U.S. Department of the Interior  
BUREAU OF LAND MANAGEMENT

**Well Name:** CANYON LARGO UNIT

## Subsequent Report

**Type of Action:** Plug and Abandonment

## Current Schematic - Version 3

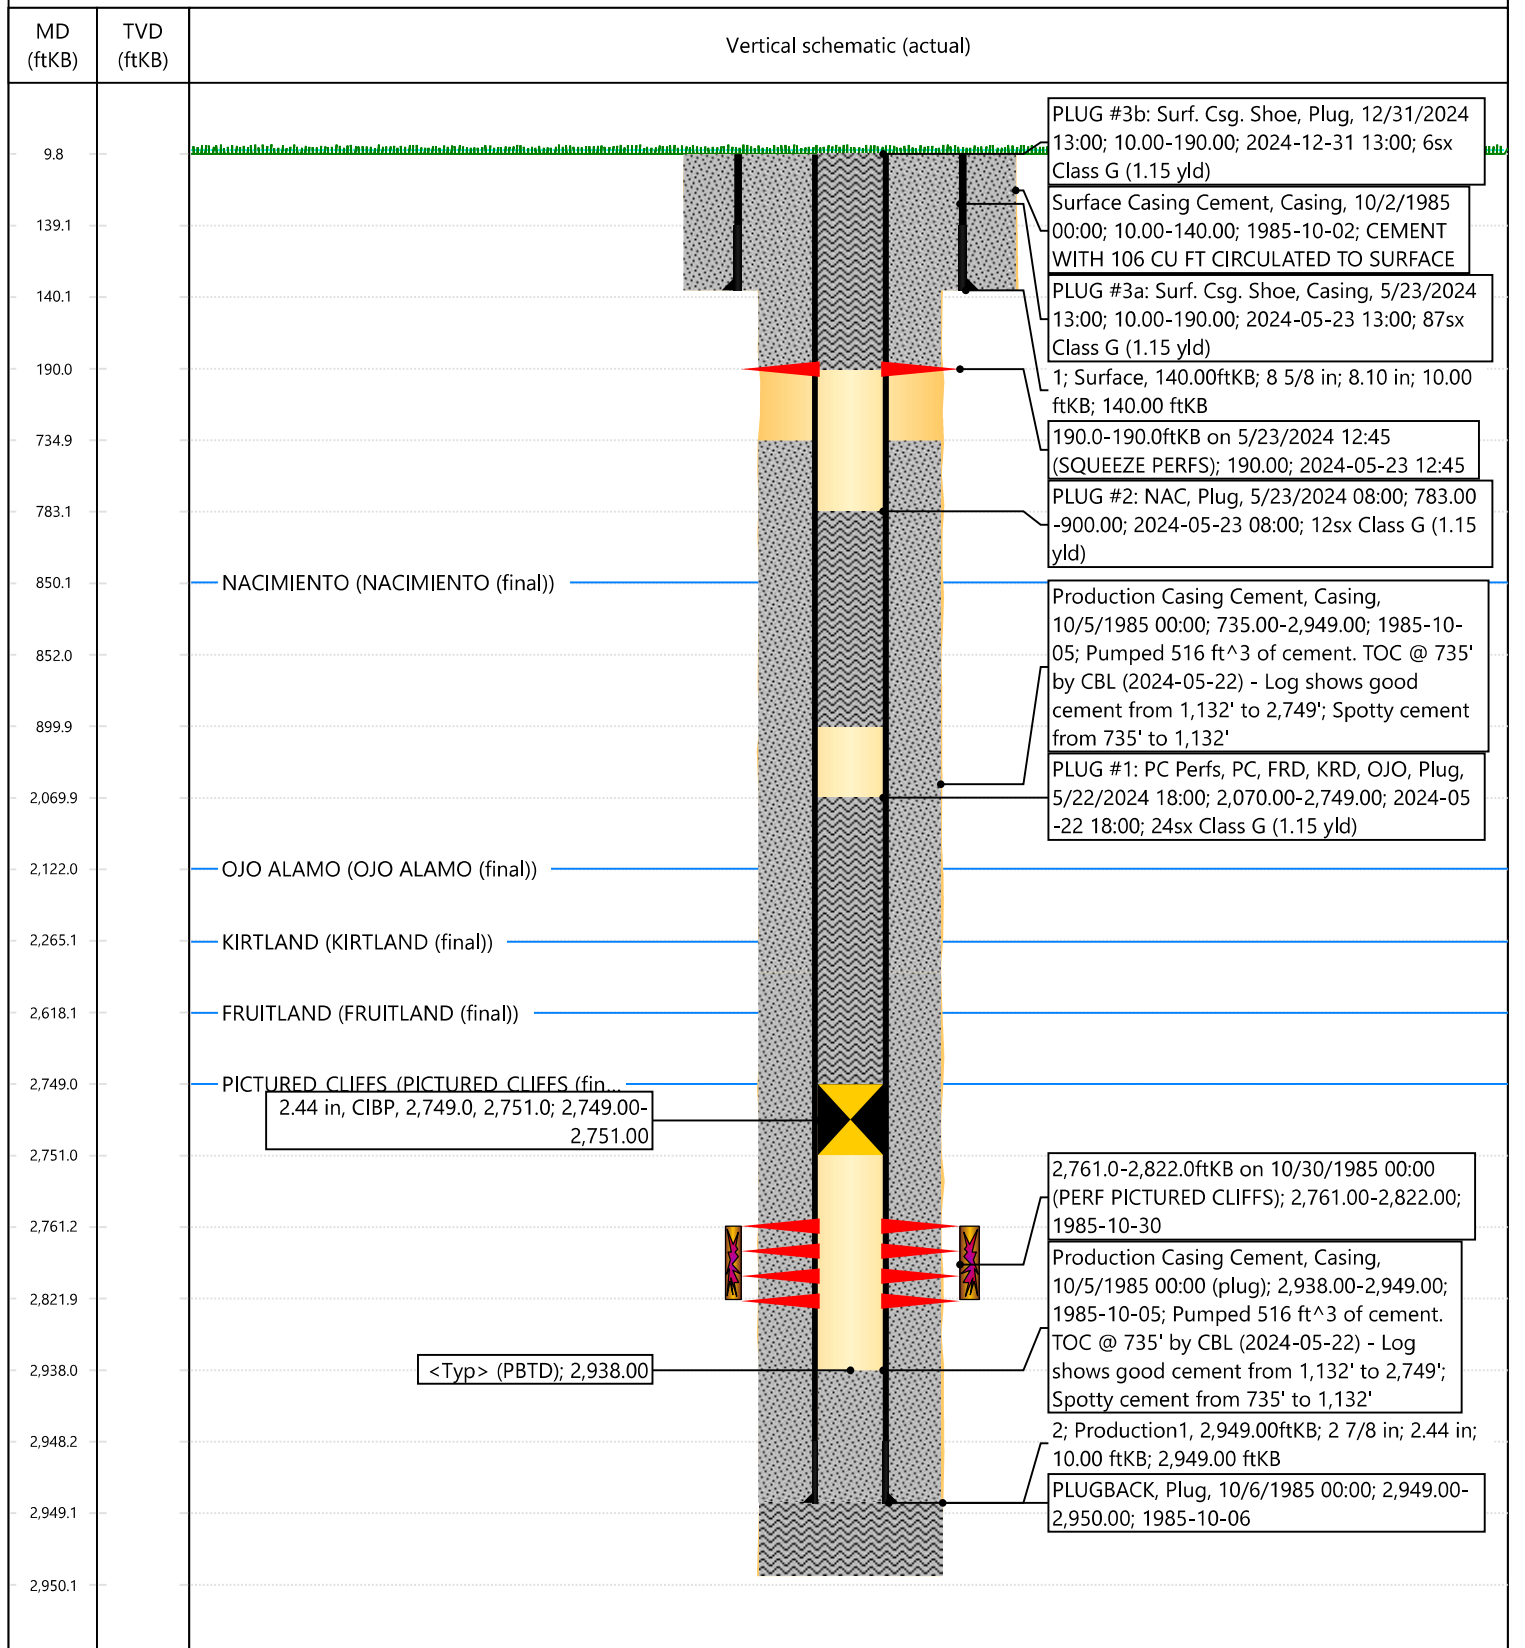
Based on the results of the CBL, Hilcorp received verbal approval from the NMOCD and BLM to make the following revisions:

- PLUG #1: 21sx of Class G Cement (15.8 PPG, 1.15 yield); PC Perfs @ 2,761' | PC Top @ 2,749' | FRD Top @ 2,618' | KRD Top @ 2,265' | OJO Top @ 2,122':
  - No changes - Pump as outlined and approved in the email chain below
- PLUG #2: 5sx of Class G Cement (15.8 PPG, 1.15 yield); NAC Top @ 850':
  - **Hilcorp received verbal approval from the NMOCD and BLM to make this an inside plug ONLY**
  - Pump a 5 sack balanced cement plug inside the 2-7/8" casing (est. **TOC @ +/- 750'** & est. **BOC @ +/- 900'**).
- PLUG #3: 54sx of Class G Cement (15.8 PPG, 1.15 yield); Surf. Casing Shoe @ 140':
  - No changes - Pump as outlined and approved in the email chain below

Based on the COAs, Hilcorp requests the following adjustments to the approved procedure:

- PLUG #1: The CIBP will be set at 2,749' (PC Perfs @ 2,761', PC Top @ 2,749'). **(NMOCD provided verbal approval for this after discussing the COAs)**
  - Pump 727" of cement on top of the CIBP from 2,022' to 2,749'.
- PLUG #2: (NAC Top @ 850')
  - This will now be an inside/outside plug (pending CBL) with an added CICR set @ 850'. See procedure attached and below.
- All other plugs have been adjusted according to the BLM & NMOCD formation tops. Please see the revised procedure attached and below.

To confirm, the BLM finds the procedure appropriate

The BLM finds the updated procedure appropriate.
